Granite School District
**SILVER HILLS ELEMENTARY
SECURITY REMODEL**
Project No. 2023.030.00

ADDENDUM NO. 1
January 23, 2024

The original specifications and drawings, dated October 31st, 2023 for the project referenced above are amended in the Addendum No. 1, dated January 23, 2024.

FLOOR, FINISH, & RCP PLANS

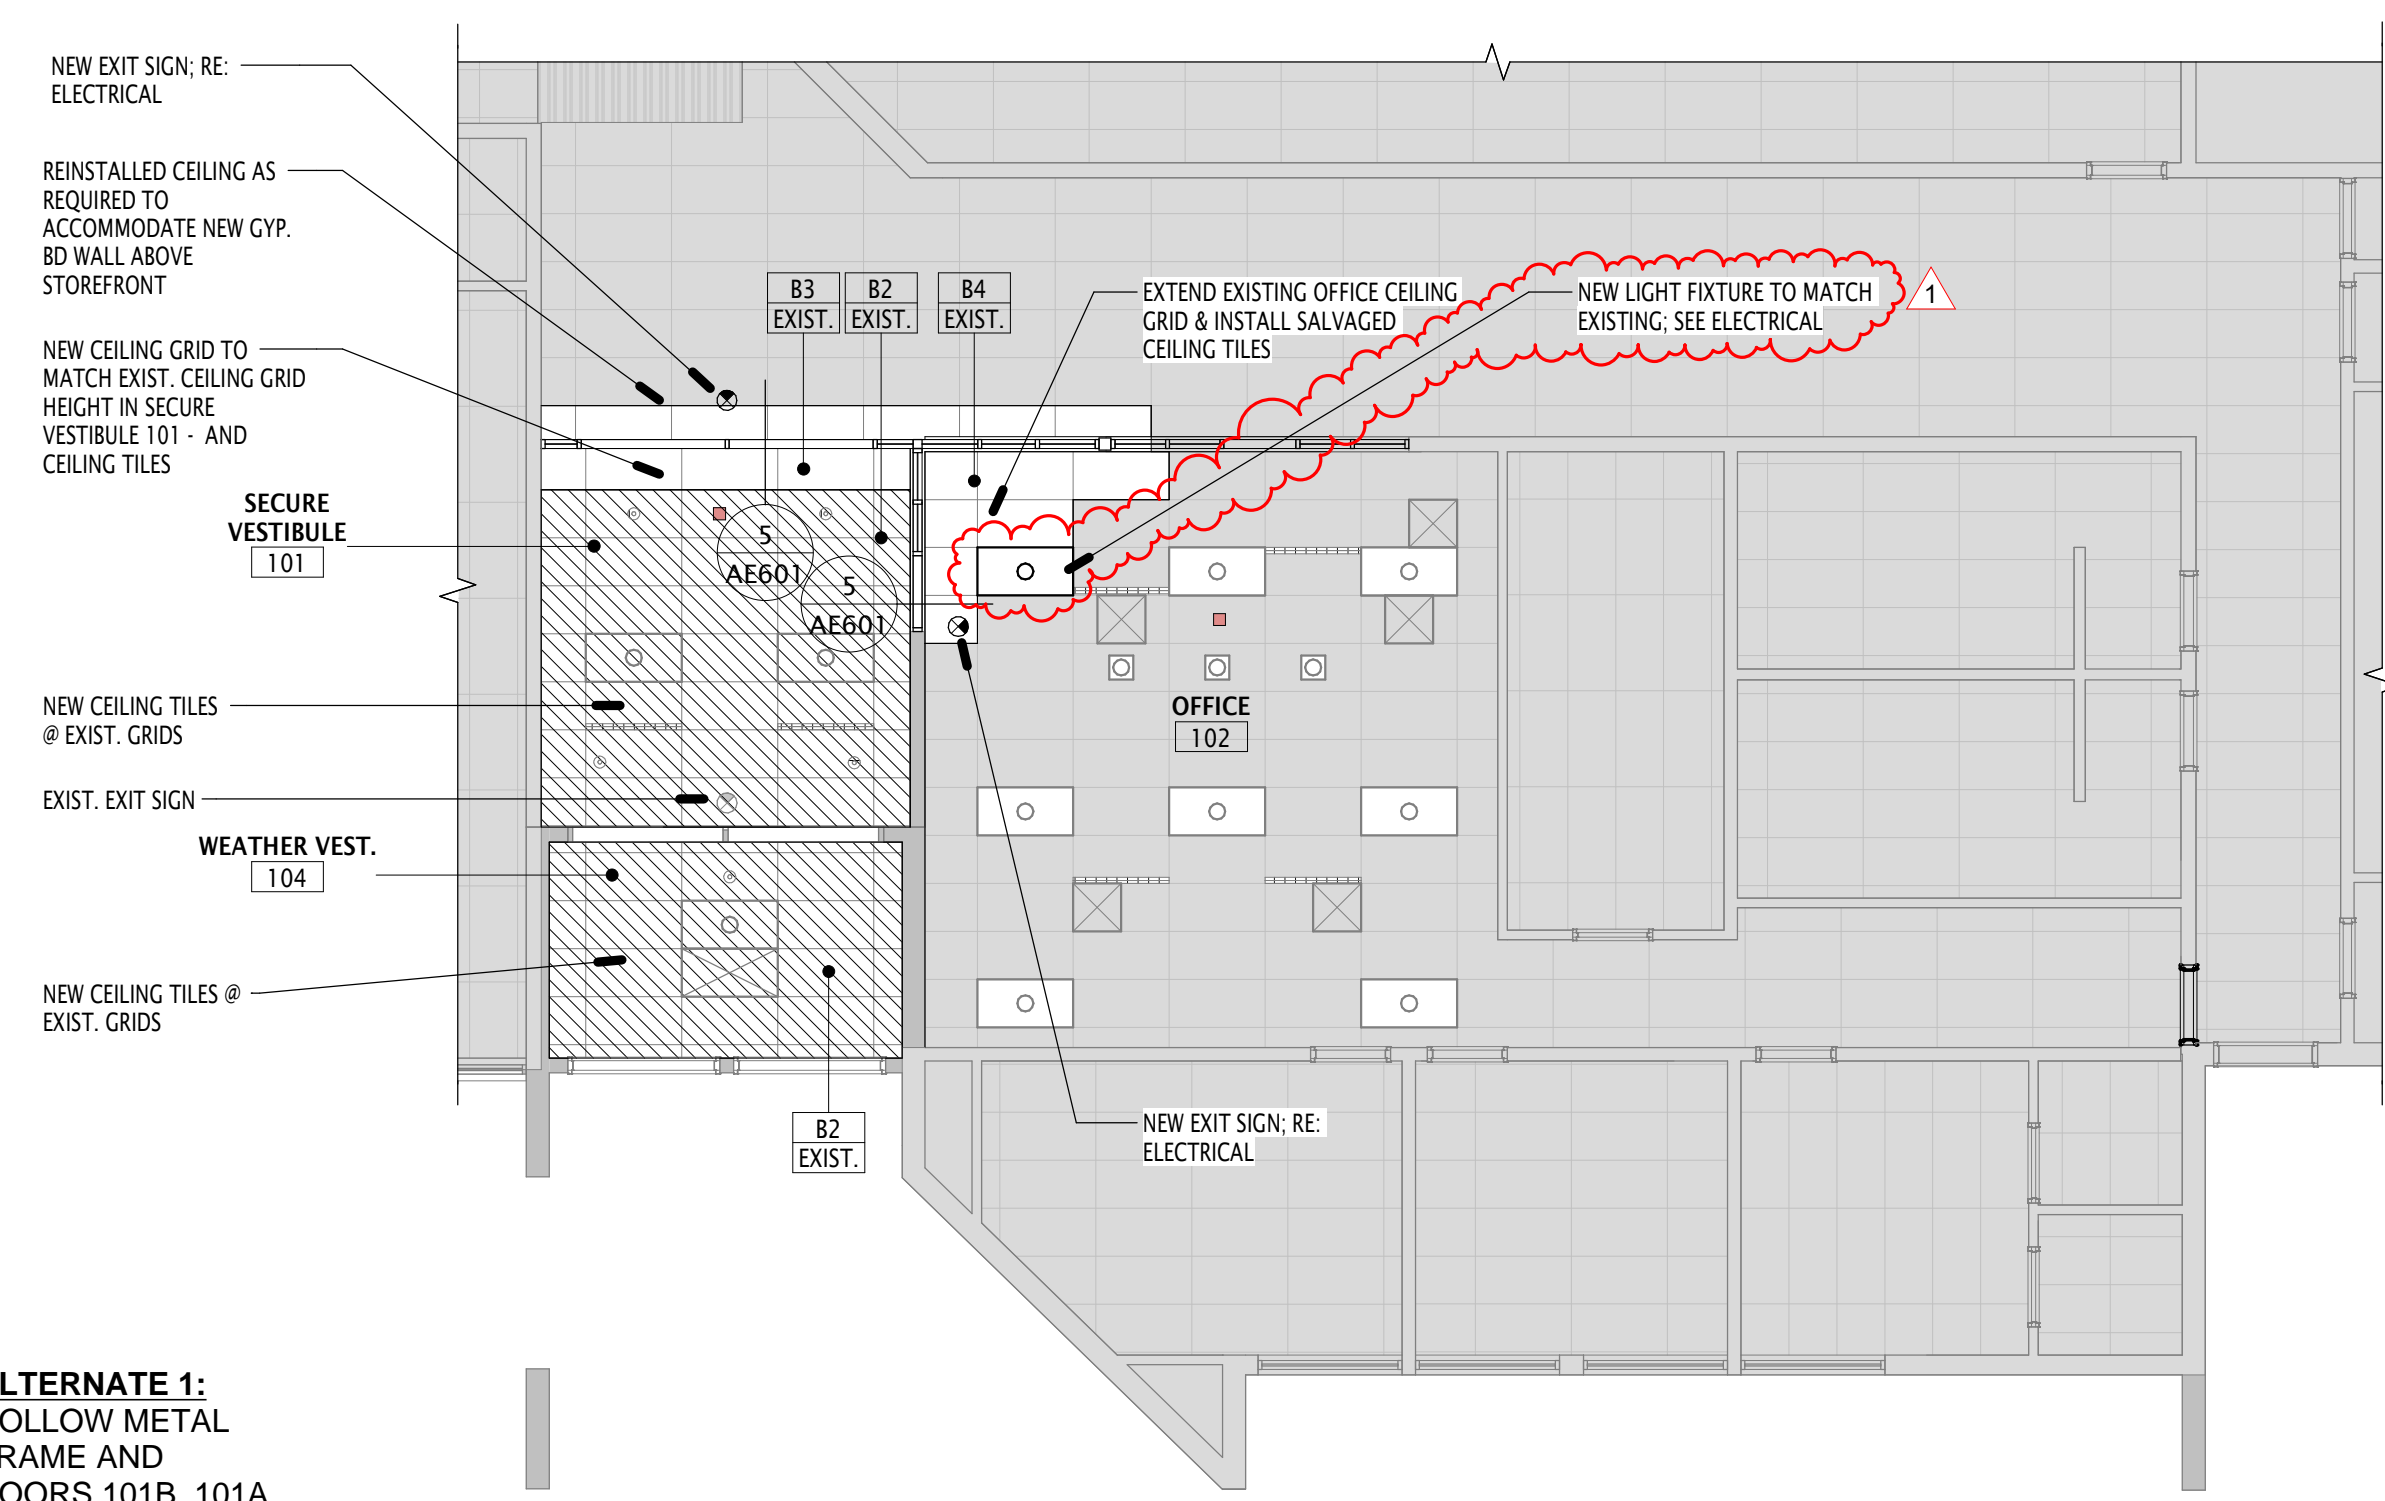
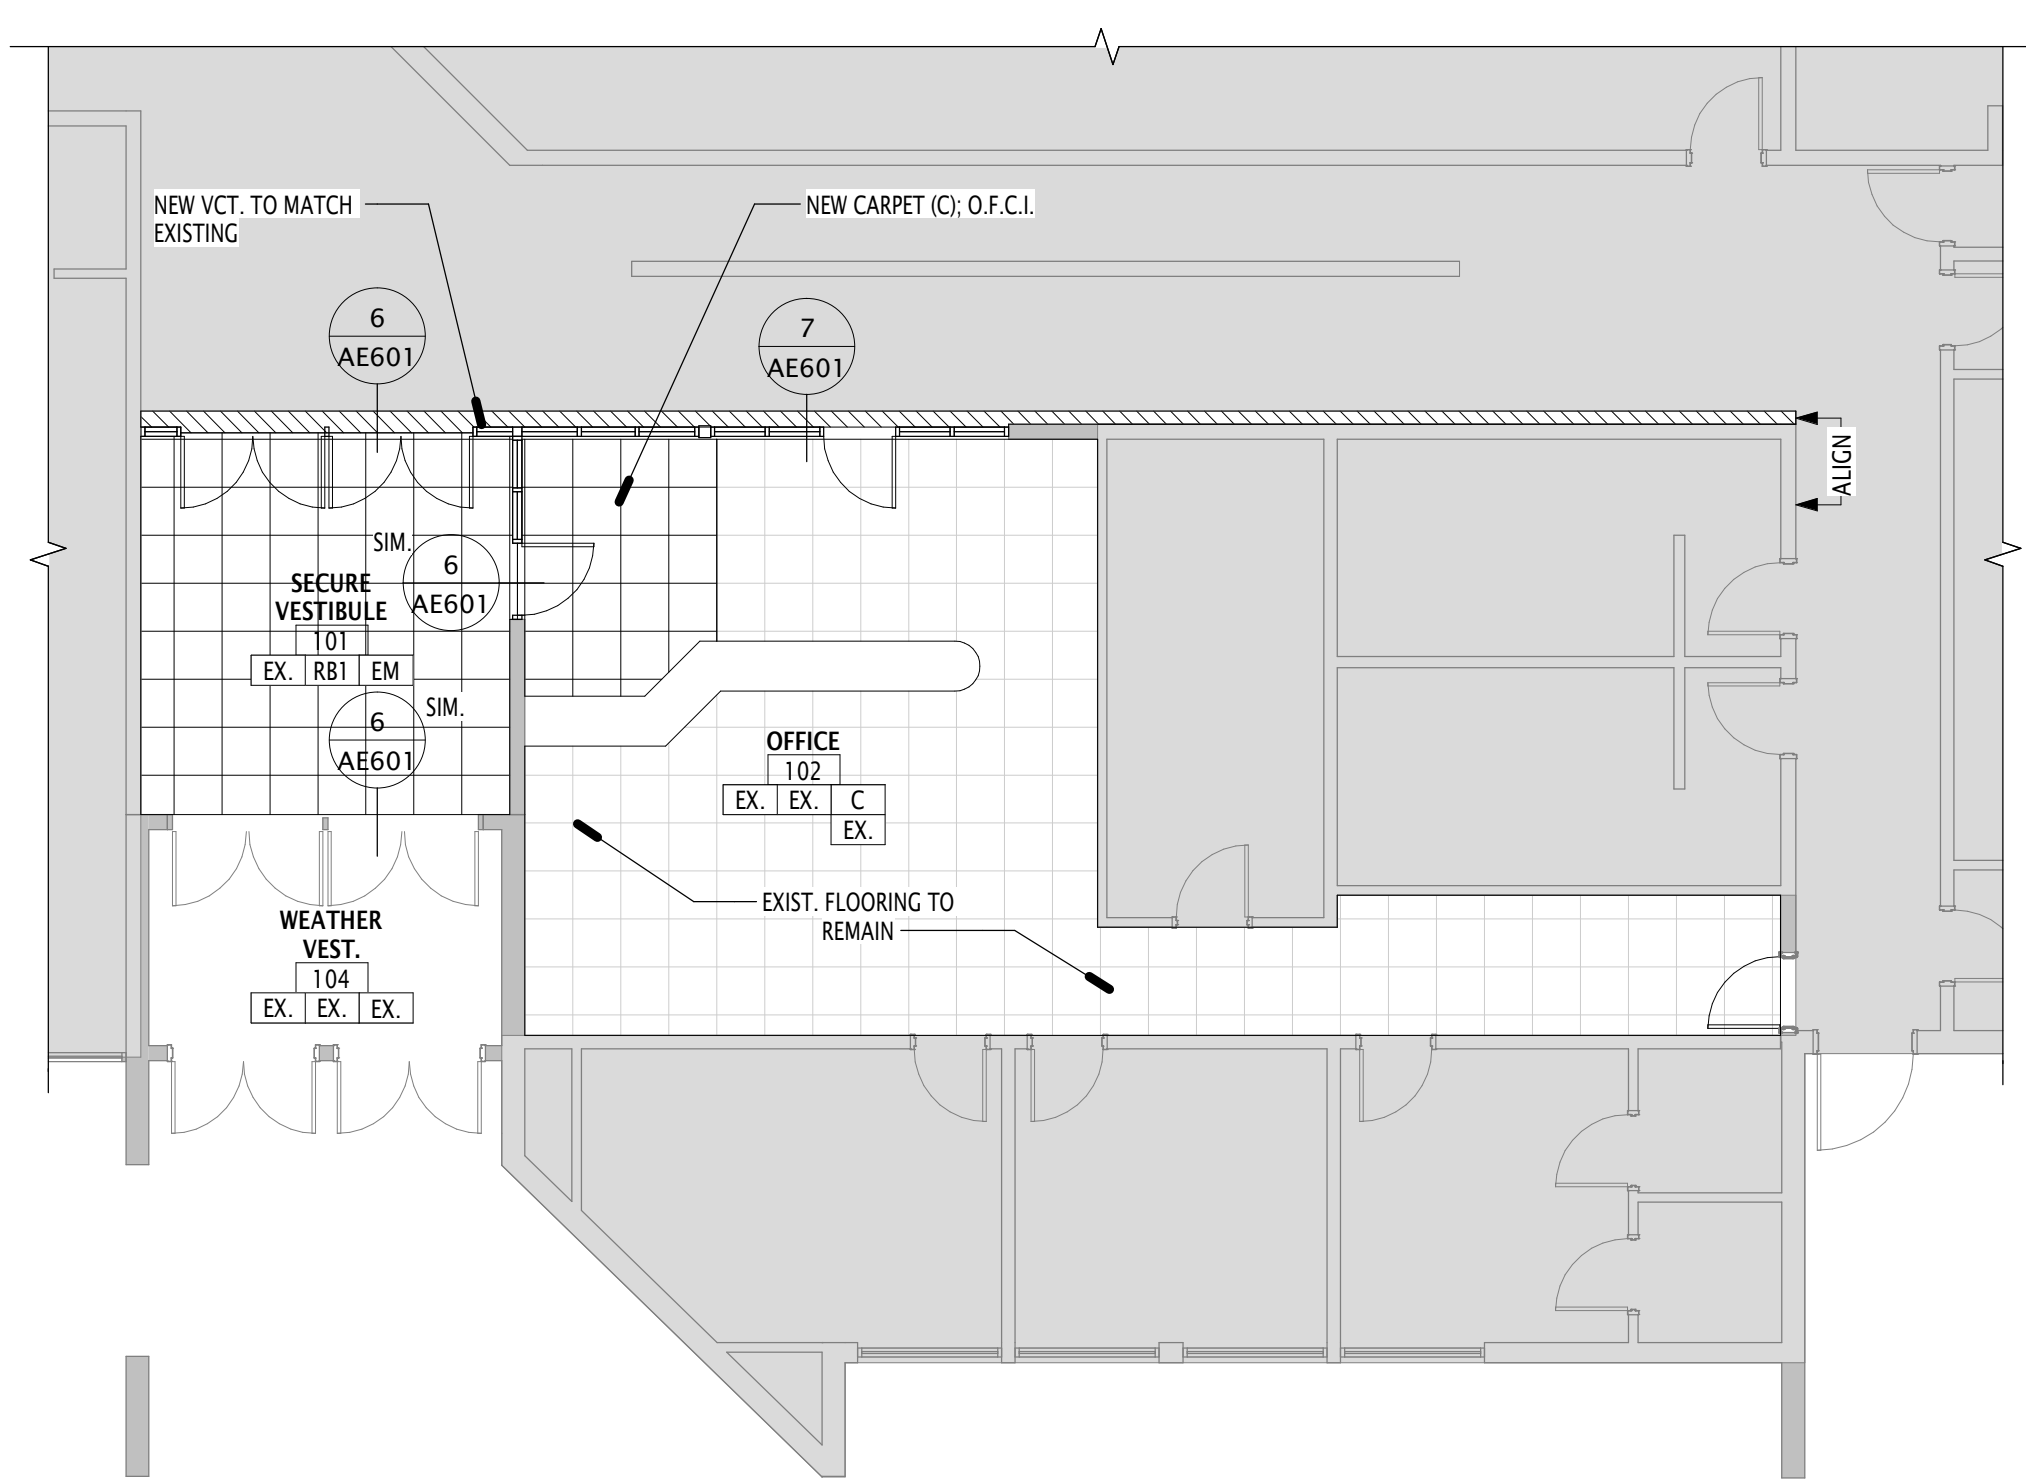
AD1-01 – Sheet AE110. Note clarification.
